**LEGAL ADVERTISEMENT  
PORTLAND PLANNING BOARD MEETING**

**AGENDA**  
**PORTLAND PLANNING BOARD**

## Planning and Urban Development Department

From: Jean Fraser, Planner

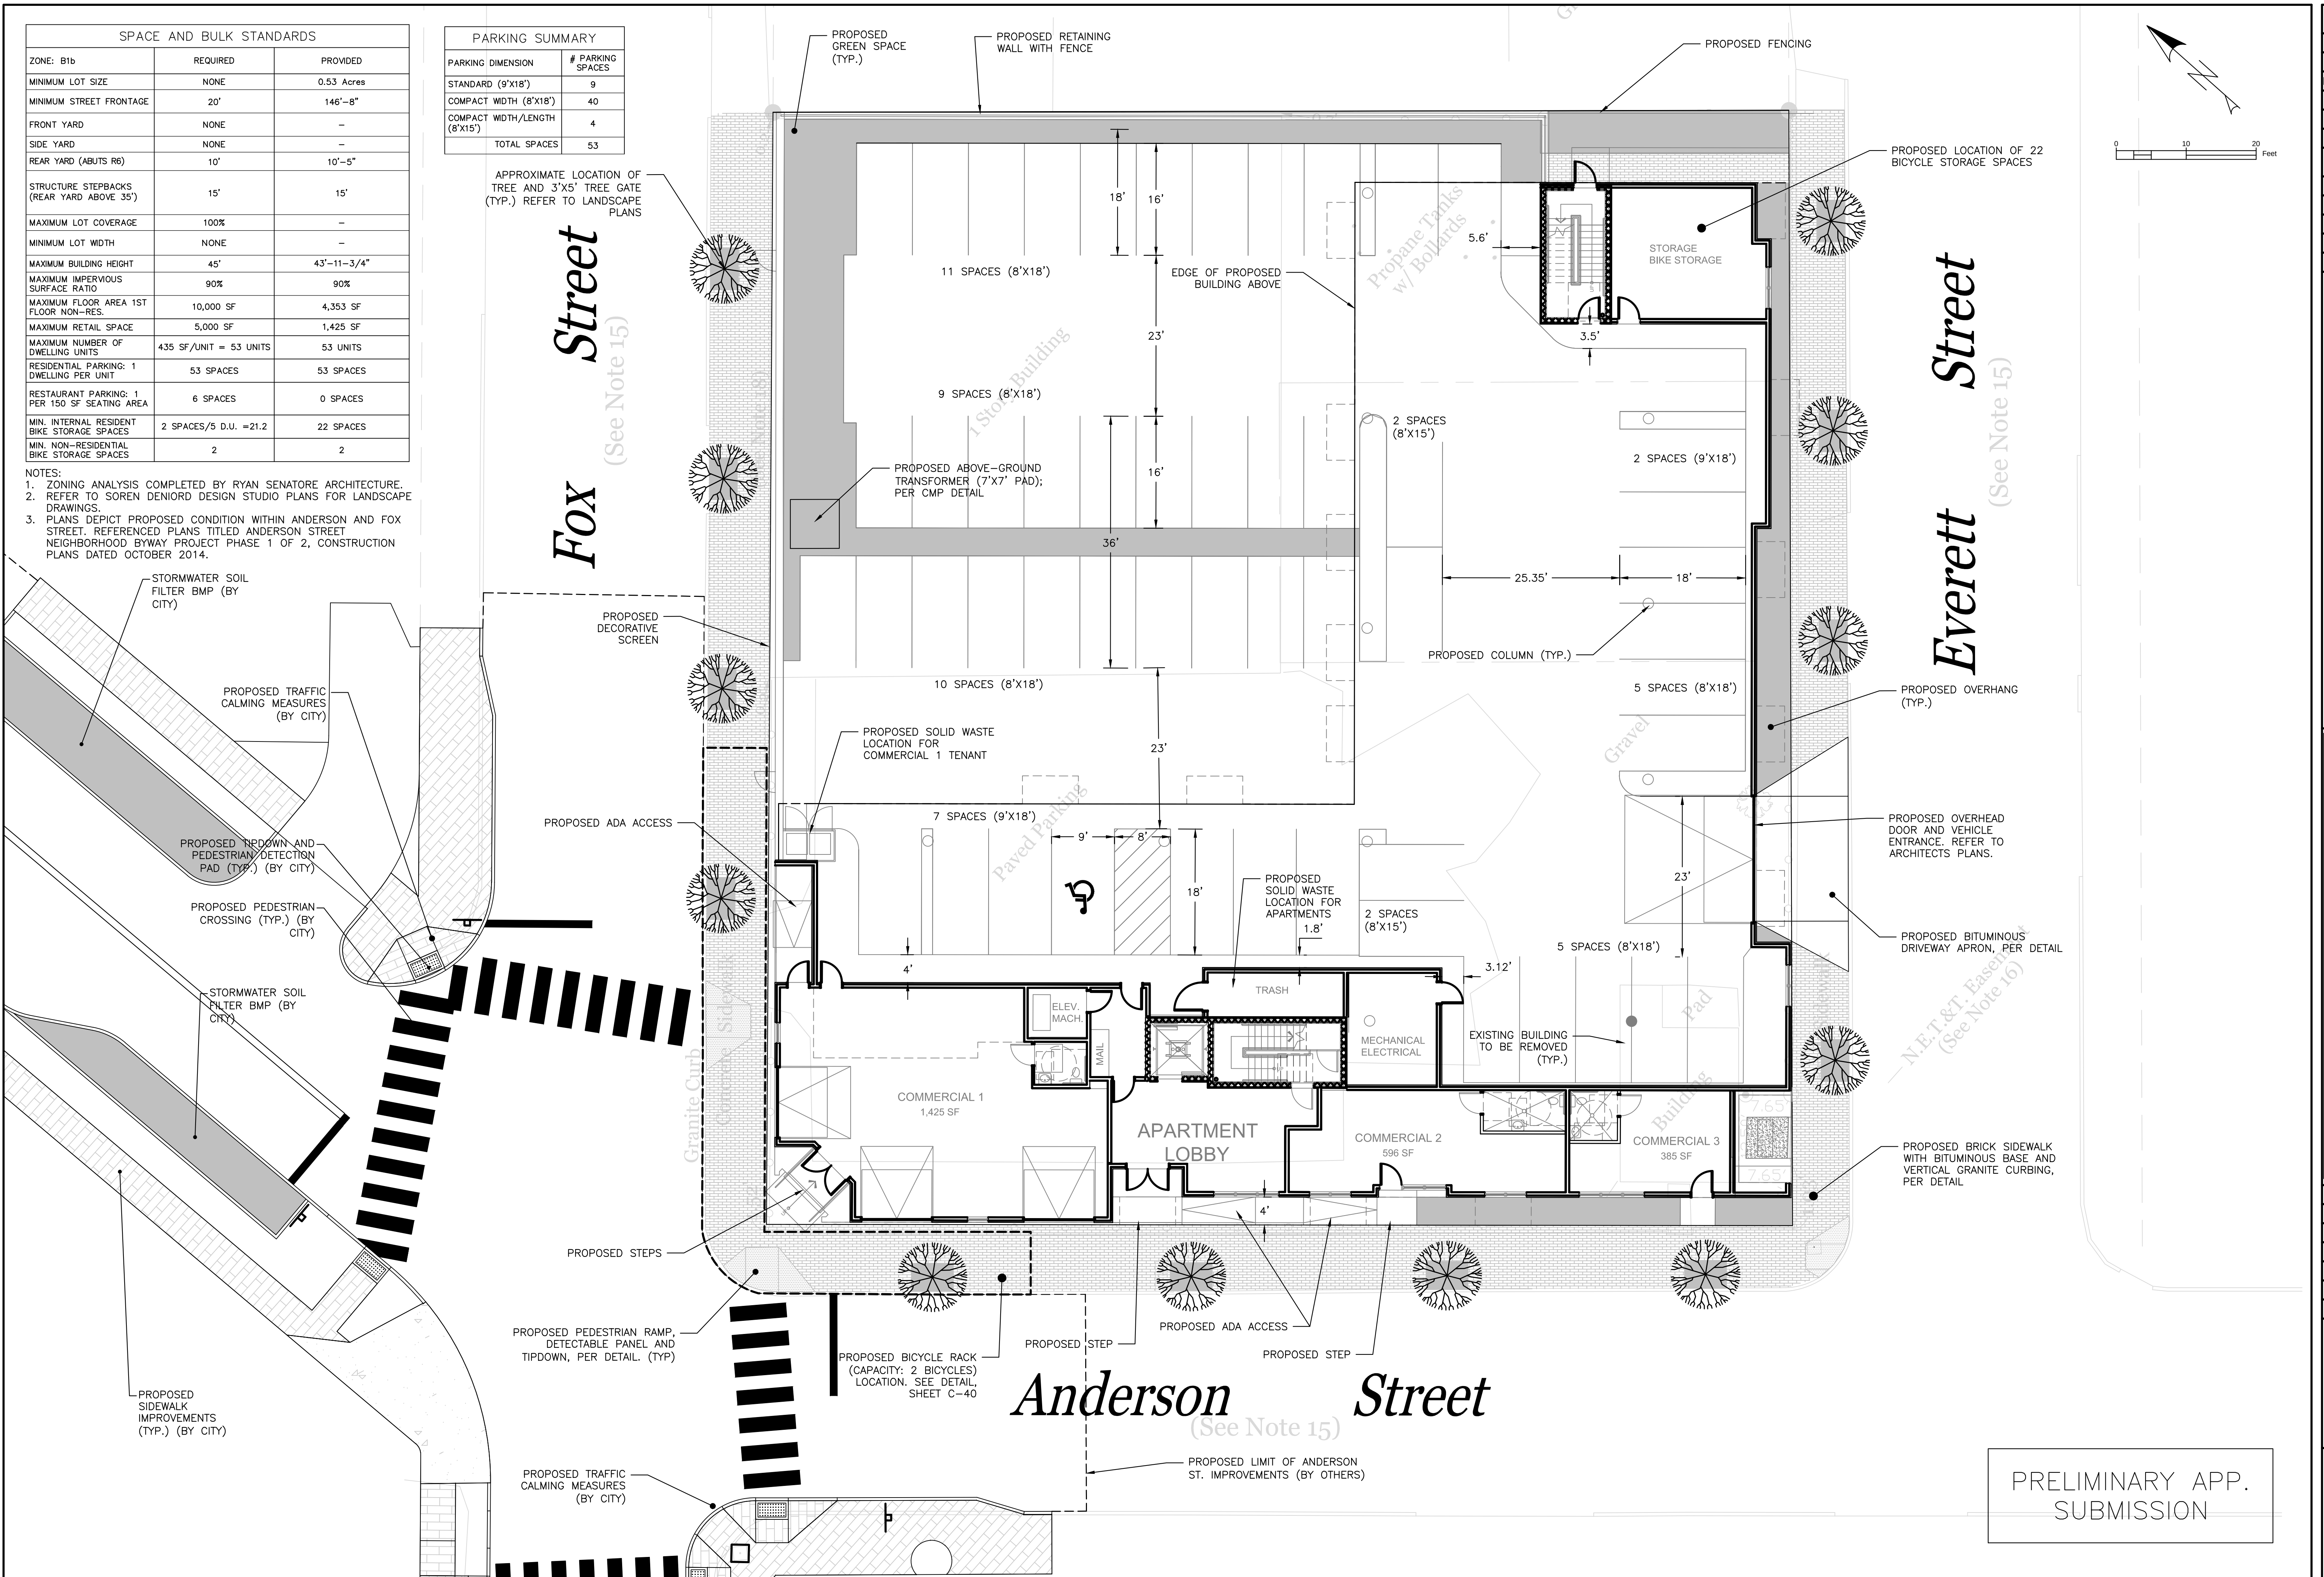
*Driveway: the construction detail and plan view (Sheet C-10) should show how the driveway will provide the required ADA-compliant accessible pedestrian route across the driveway (max 2% cross-slope) - if needed, this can be accomplished by having a steeper slope for the first 2'-3' of the driveway (where it meets the street) and then a maximum cross-slope of 2% for the 4'-5' closest to the building.*

Driveway: the construction detail and plan view (Sheet C-10) should show how the driveway will provide the required ADA-compliant accessible pedestrian route across the driveway (max 2% cross-slope) - if needed, this can be accomplished by having a steeper slope for the first 2'-3' of the driveway (where it meets the street) and then a maximum cross-slope of 2% for the 4'-5' closest to the building.

CITY OF PORTLAND TYPICAL PIPE TRENCH DETAIL

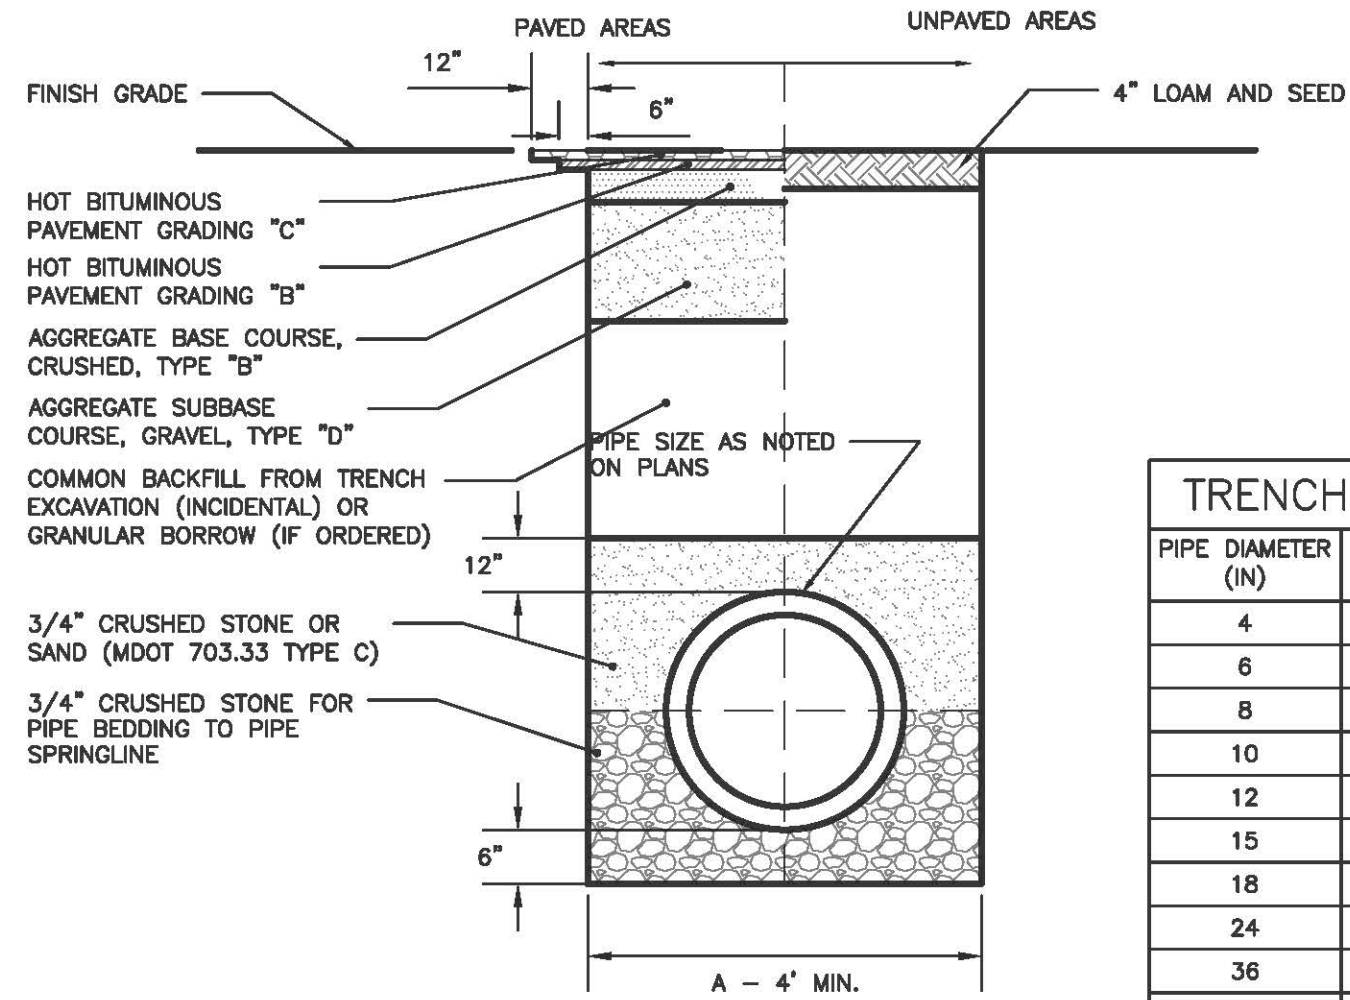
*The Applicant has provided a "City of Portland Typical Pipe Trench Detail" (Sheet C-42), and a separate "Storm Drain, Sewer, and Water Typical Trench Section Detail" (Sheet C-43). The Applicant should clarify where these two details are to be used. The "City of Portland Typical Pipe Trench Detail" should be utilized for all storm drain and sewer pipe work within the City Right-of-Way.*

- 8) The Applicant has provided a sloped granite curb detail; the Applicant should clarify where sloped granite curb is proposed.
- 9) The Applicant has provided a "City of Portland Typical Pipe Trench Detail" (Sheet C-42), and a separate "Storm Drain, Sewer, and Water Typical Trench Section Detail" (Sheet C-43). The Applicant should clarify where these two details are to be used. The "City of Portland Typical Pipe Trench Detail" should be utilized for all storm drain and sewer pipe work within the City Right-of-Way.
